Access Compliance Report Public Rights-of-Way (Curb Ramps)

Intersection ID: 32321 Main Street: CHURCHFIELD_LN Cross Street: CAROLINA_ACADEMY_RD Location: N

ADA ID: 8B2DE510BDE7 Ramp Type: PerpDiag Initial Pass/Fail: Fail Overall Compliance: No Severity Score: 13.75

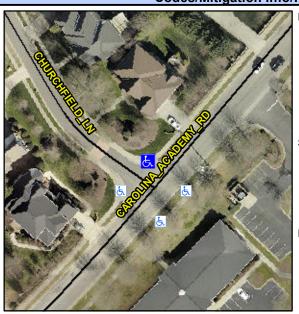
Remove & Replace Curb Ramp With Two New Directional Ramps or Equivalent.

R304.2.2, R304.5.3
